# ADDENDUM NO. 3

Rochester City School District

Dr. Walter Cooper, School #10

March 7<sup>th</sup>, 2018

**S2007**

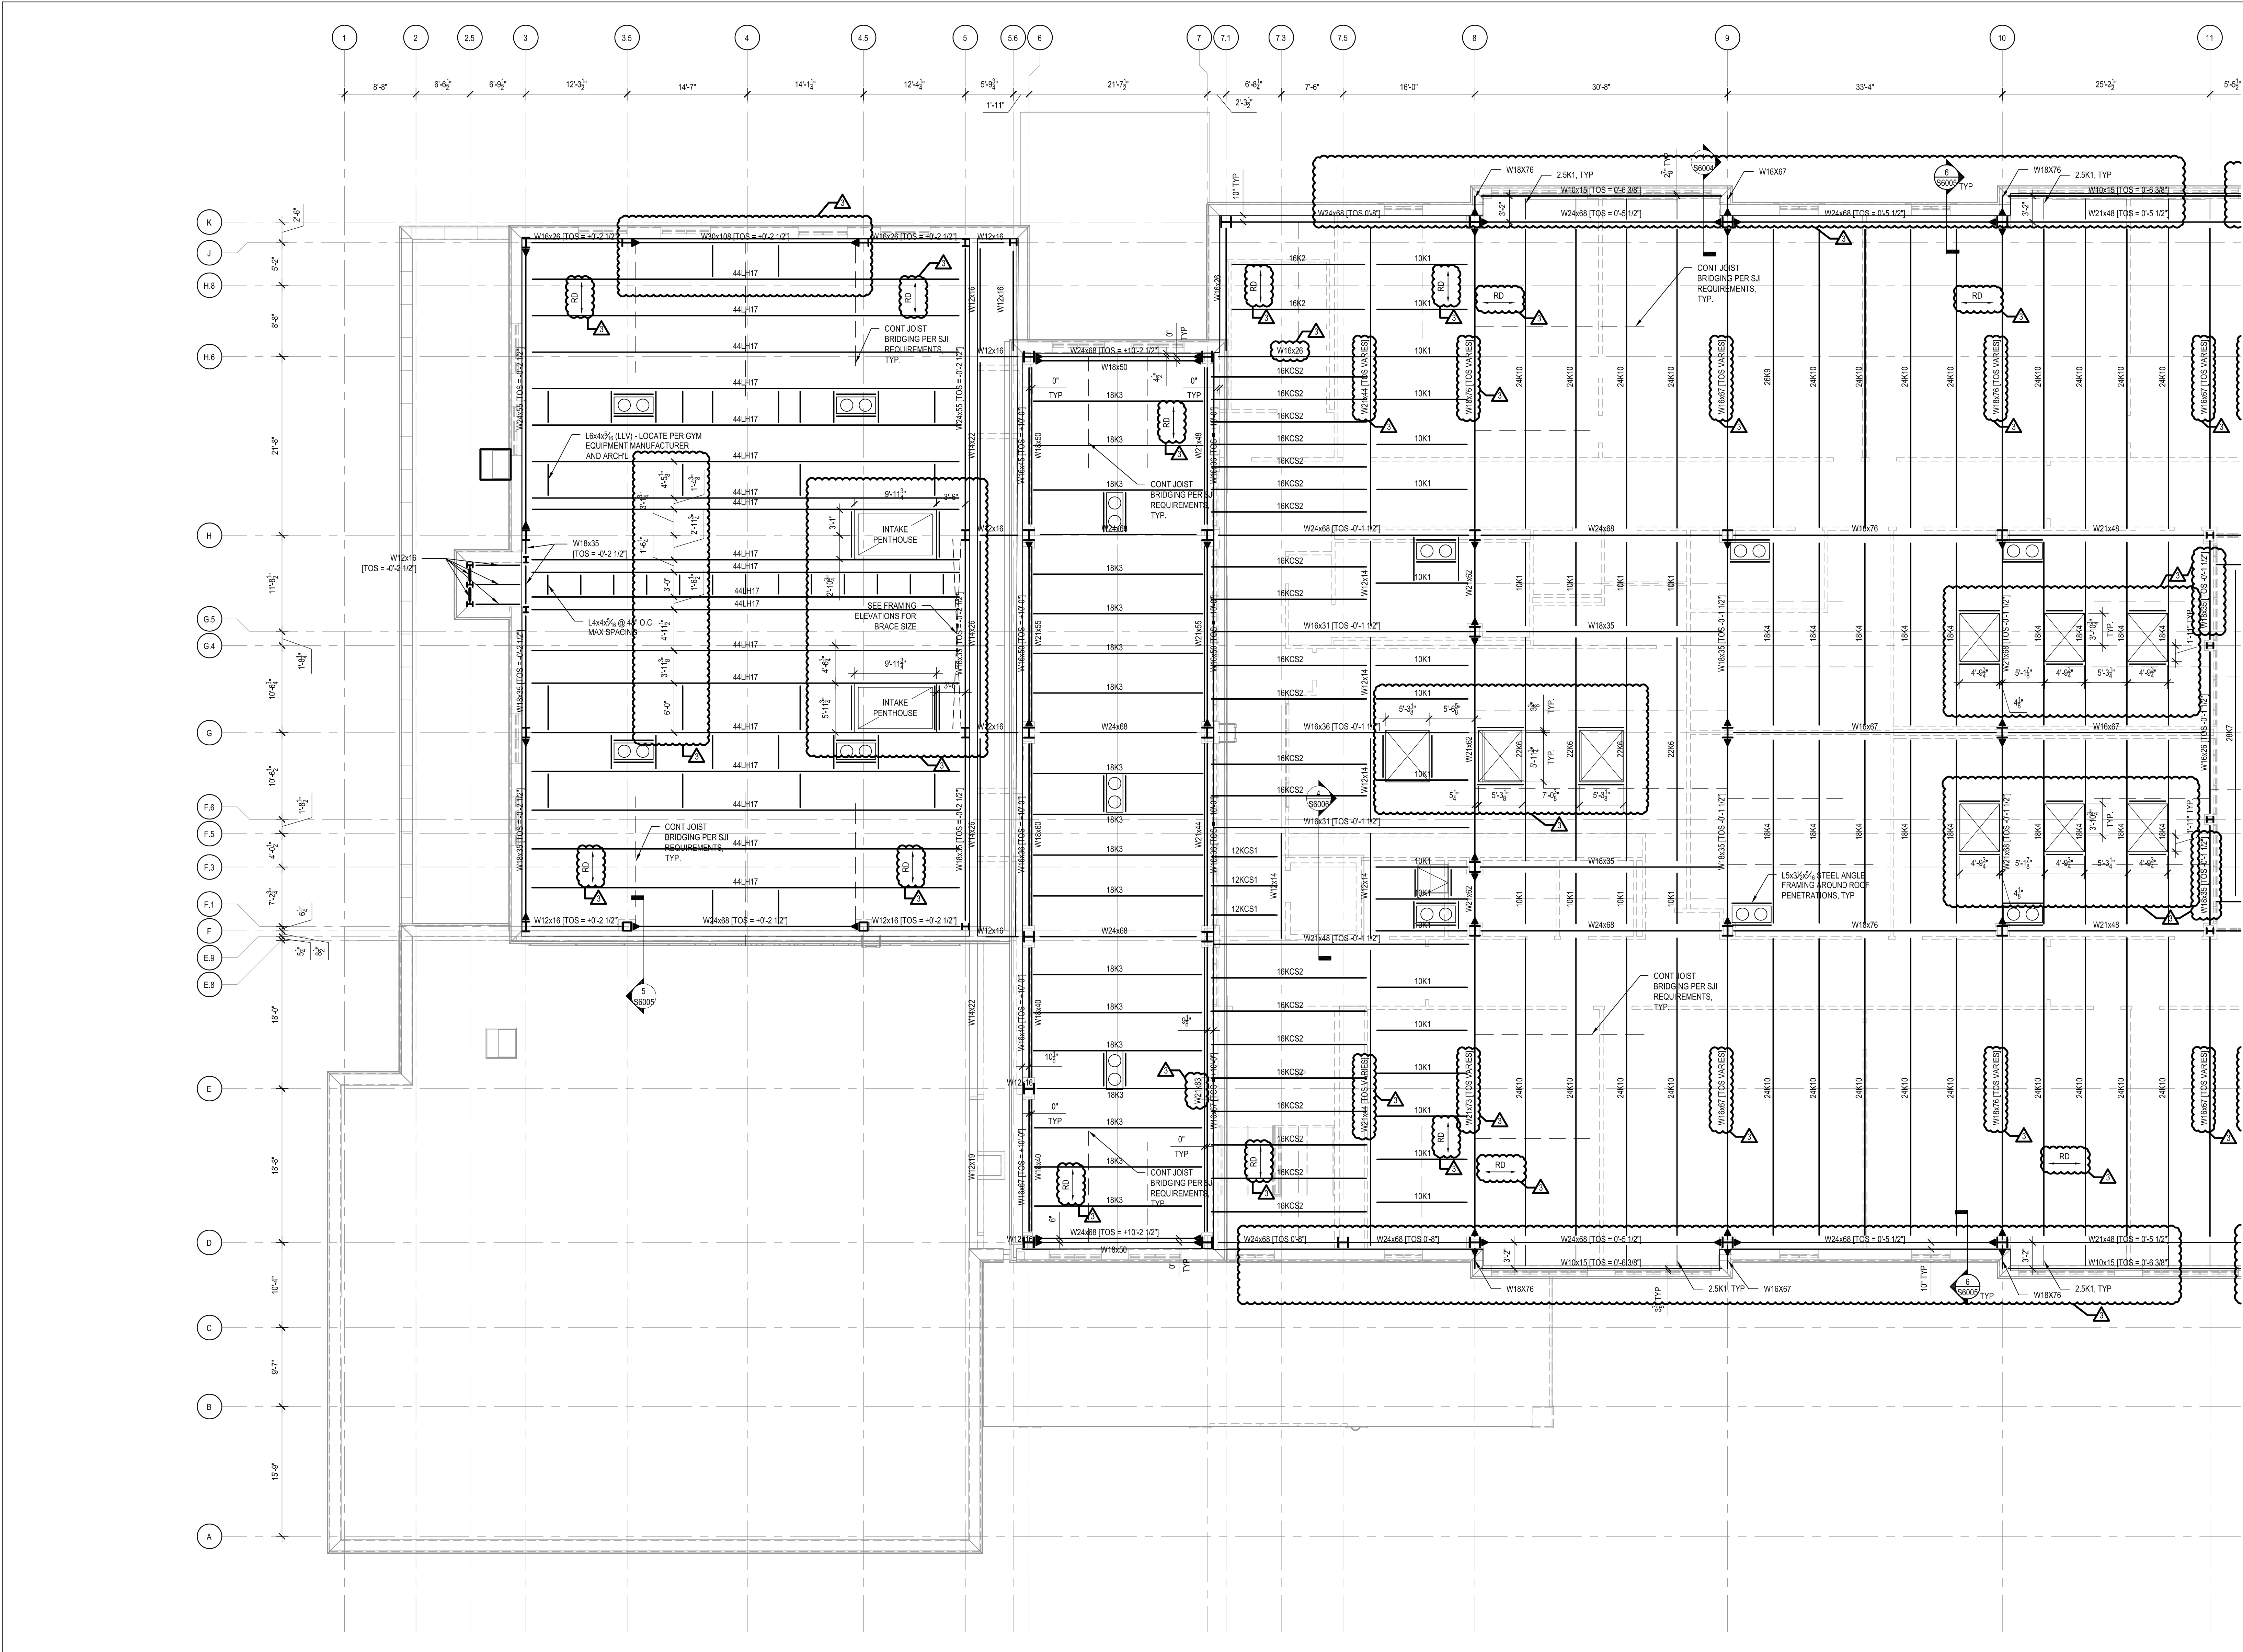
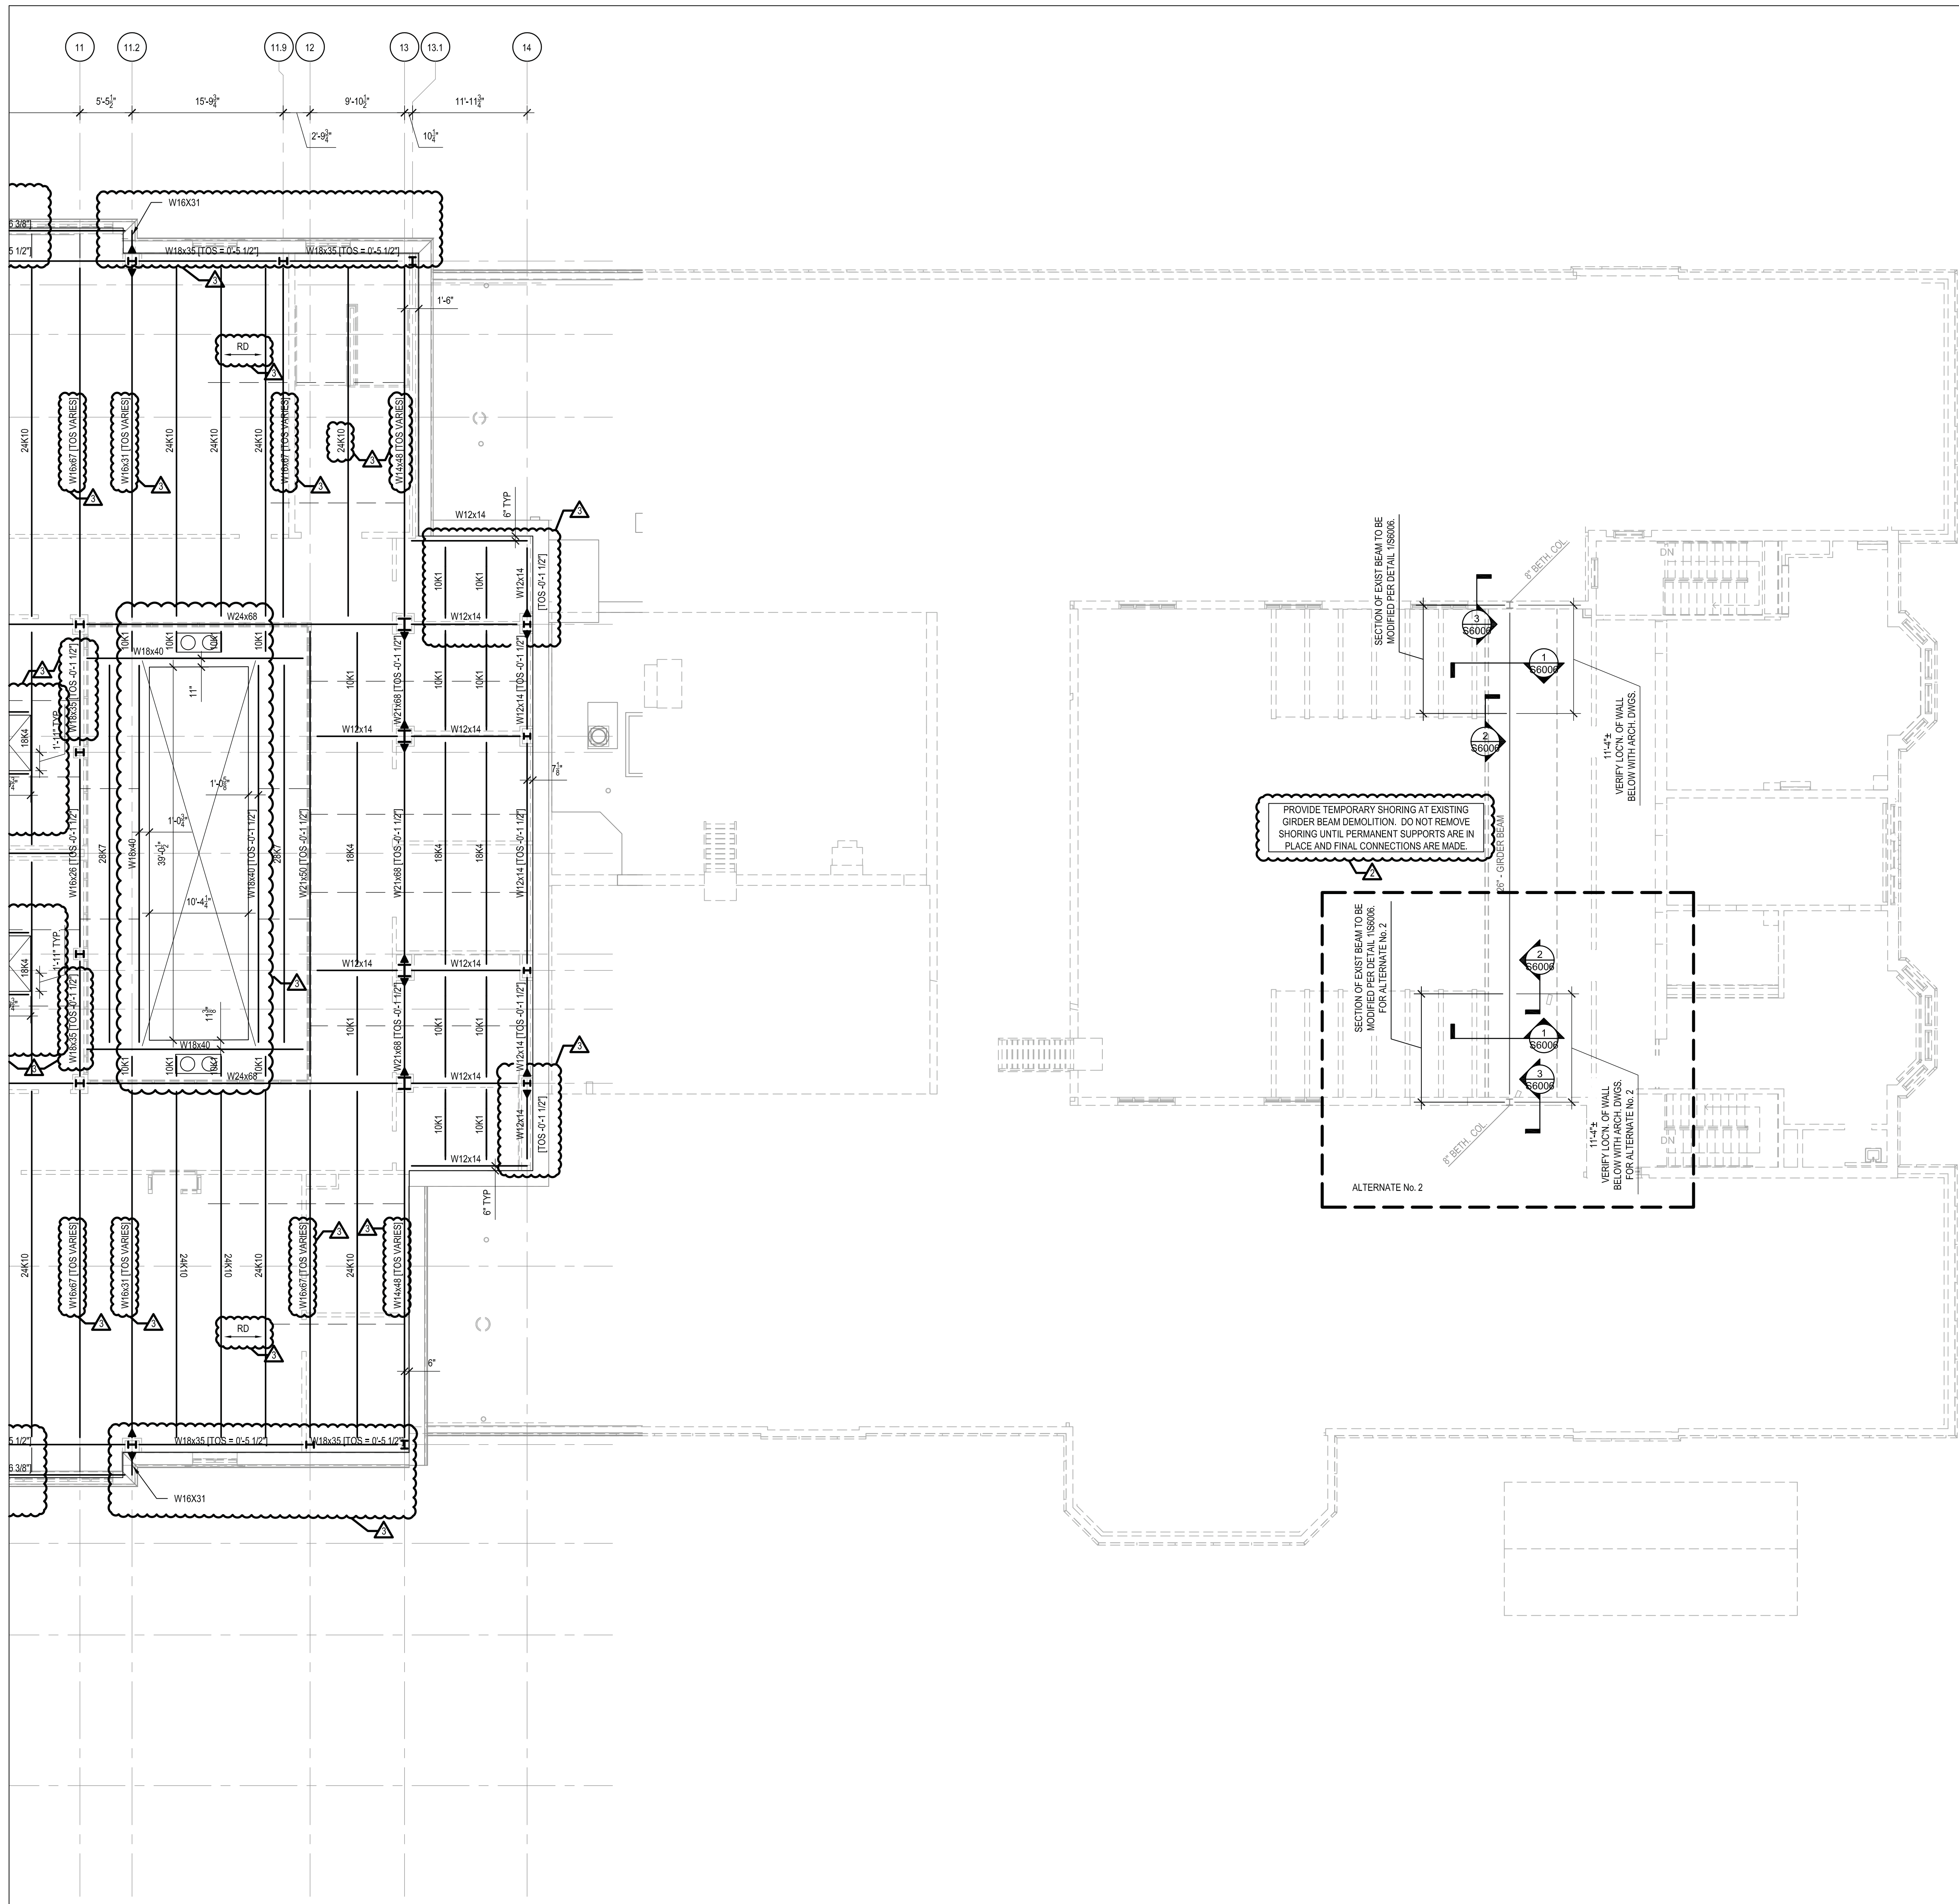
- Item AD3-48 **REPLACE** drawing in its entirety with attached "S2007 – PARTIAL ROOF FRAMING PLAN," deleting vertical bracing at grid line J; adding vertical bracing at grid line 5; revising dimensions of roof joist at intake penthouses; revising deck edges at intake penthouses; adding roof deck callout and span direction; revising top of steel elevations along grid line D; revising top of steel elevations along grid line K; revising top of steel elevations along grid line D; revising beam sizes between grid lines D & F and between grid lines H & K; revising deck edges at skylights; revising Roof Framing Notes #3 - #5.
